- 1. Corea Bend Subdivision 2022 Addition**
KPB File 2022-131
Johnson Surveying / Blossom & Duncan
Location: Haybale Ln., Corea Bend Rd. & Janny's Ave.
Ninilchik Area

ITEM 1 - COREA BEND SUBDIVISION 2022 ADDITION

KPB File No.	2022-131
Plat Committee Meeting:	September 26, 2022
Applicant / Owner:	David & Katie Blossom and Heath & Diane Duncan all of Kasilof, AK
Surveyor:	Jerry Johnson / Johnson Surveying
General Location:	Corea Bend Road & Floyd Blossom Ave, Ninilchik area

STAFF REPORT

PRELIMINARY PLAT

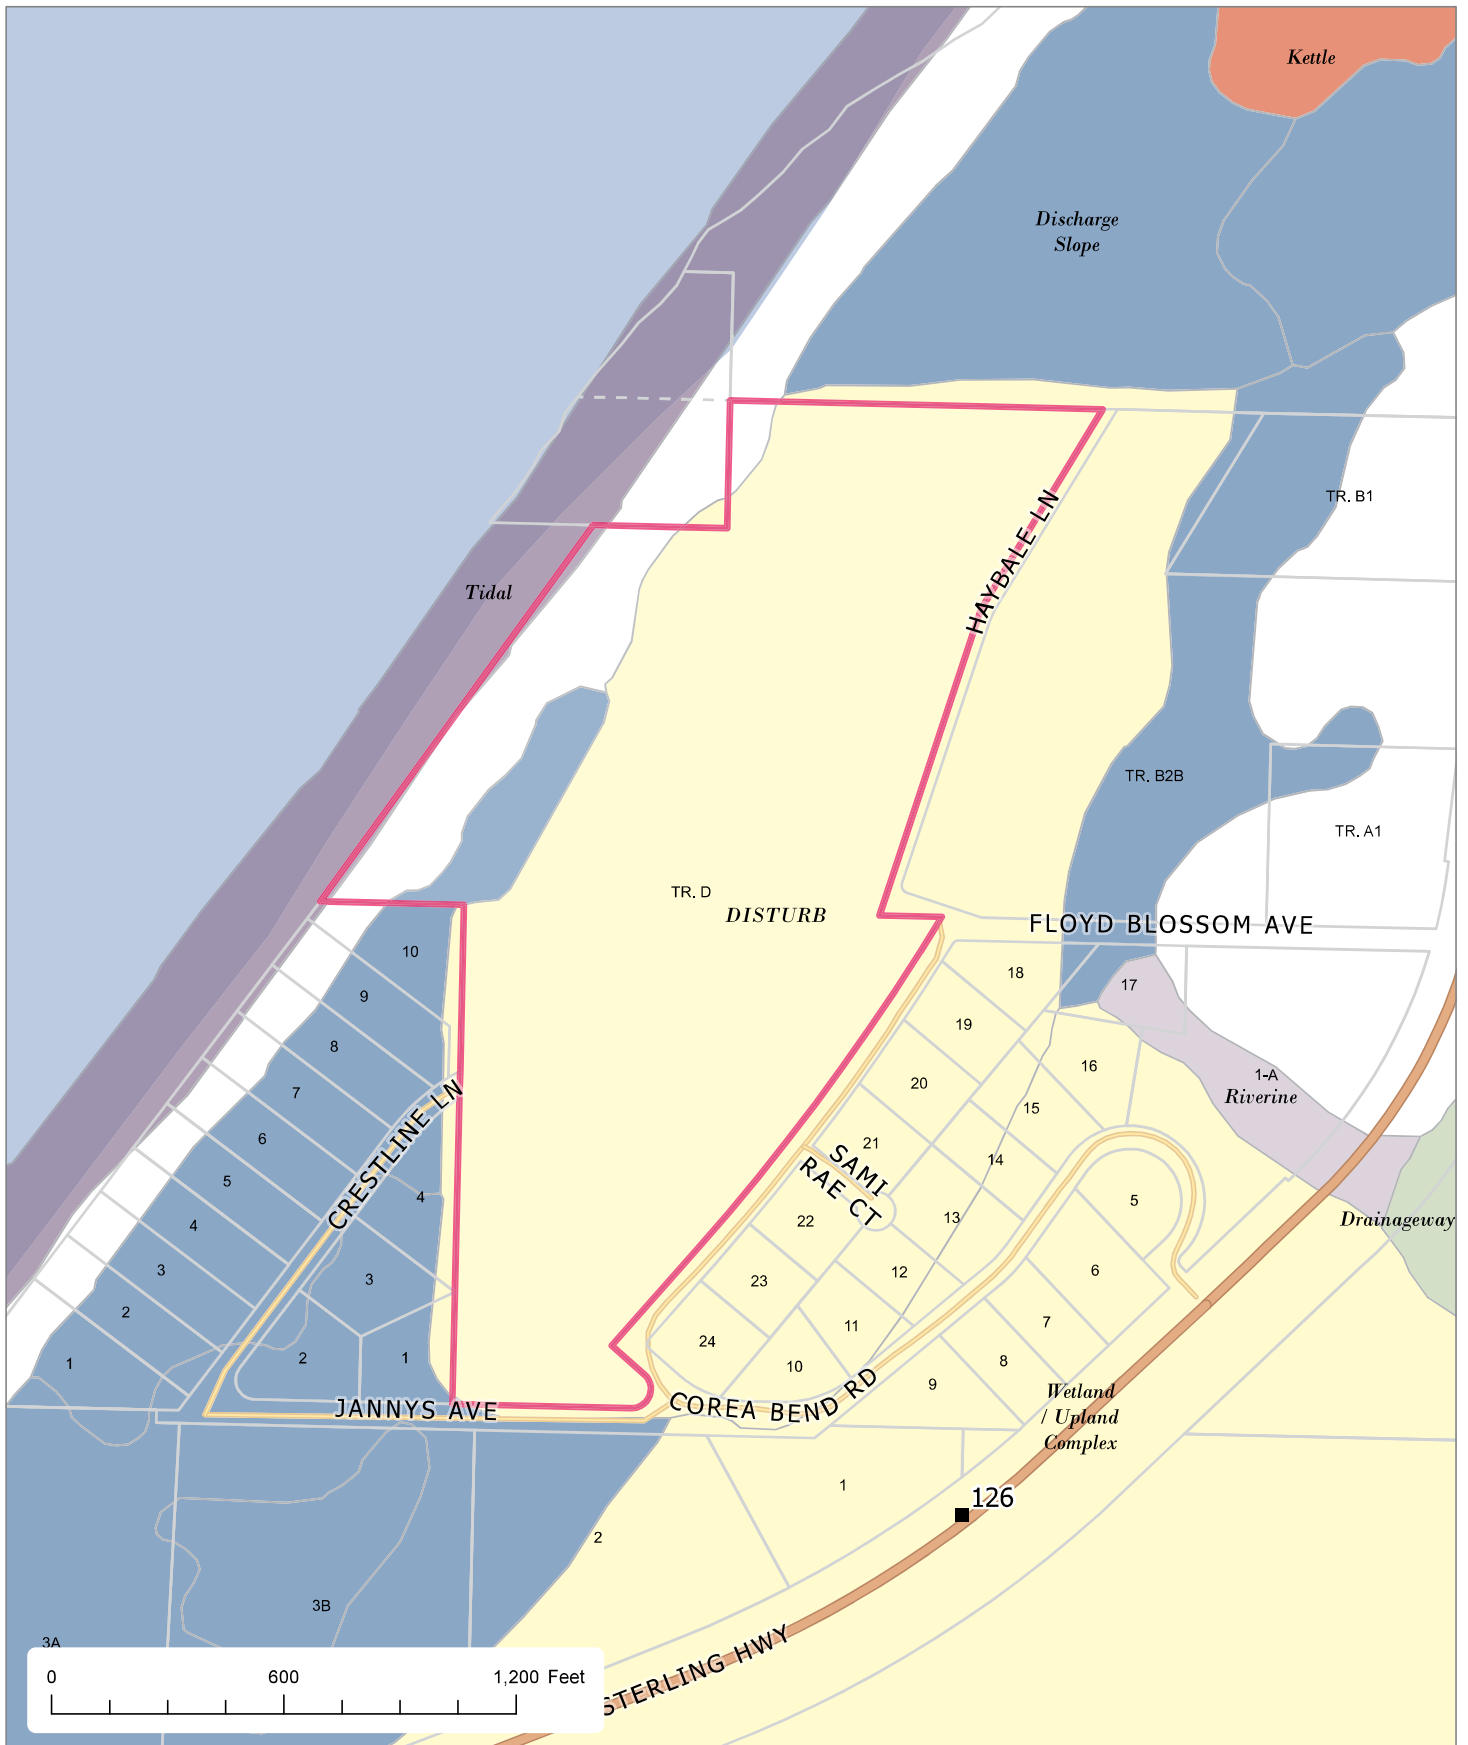
top of the bluff and approximate base is shown on the plat. **Staff recommends the top and base of the bluff remain on the final plat.**

The base of the bluff as shown is also being labeled as the limits of tidal flooding. Other than some of the steep terrain, the majority of the property is considered to be wetlands per KPB GIS data. There is a creek running along the proposed new lot line that is not within the anadromous streams catalog. **Staff recommends the creek remain on the final plat, due to the majority being wetlands do not depict on the final plat but add a note that wetlands may be present and the wetland determination note.**

Move text from the line on the west to read better.

Staff recommendation: *In the located portion remove "Gov Lot 10 and the".*
- C. The location, width, and name of existing or platted streets and public ways, railroad rights-of-way, and other important features such as section lines or political subdivisions or municipal corporation boundaries abutting the subdivision;

Staff recommendation: *Adjacent street names not shown, of those shown some are incorrect labeled.*
- D. A vicinity map, drawn to scale showing location of proposed subdivision, north arrow if different from plat orientation, township and range, section lines, roads, political boundaries, and prominent natural and manmade features, such as shorelines or streams;

Staff recommendation: *Remove the line and arrow with "Ninilchik 9 miles" label. Not required but if wanting to give a better idea of location could add milepost of the Sterling Highway.*
- F. The location, width and name of existing and platted streets and public ways, railroad rights-of-way, easements, and travel ways existing and proposed, within the subdivision;

Staff recommendation: *Labels that indicate the dedications occurring should be added as wells as street name labels*
- G. The status of adjacent lands within 100 feet of the proposed subdivision boundary or the land status across from any dedicated rights-of-way that adjoin the propose subdivision boundary, including names of subdivisions, lot lines, block numbers, lot numbers, rights-of-way; or an indication that the adjacent land is not subdivided;

Staff recommendation: *Lands within 100 feet not labeled correctly to the northeast. Block numbers need to be added to the lands to the southwest. Government Lot 9 can have the unsubdivided label removed as Government Lot 9 is the designation. To the north of the subdivision replace the unsubdivided label with Government Lot 7. For abutting southern lots on both sides of the subdivision, adjust the subdivision name labels to indicate that lots on both sides of their rights-of-way are part of the same subdivision or add a second label for each.*

Staff recommendation: comply with 20.60.110. Show measured and recorded dimensions. Some data missing. Provide a line and curve table to clean up the drawing. Provide source of meander line.

Staff recommendation: Bearings and distances are missing on GLO line on south and tie to plat. Comply with 20.60.200
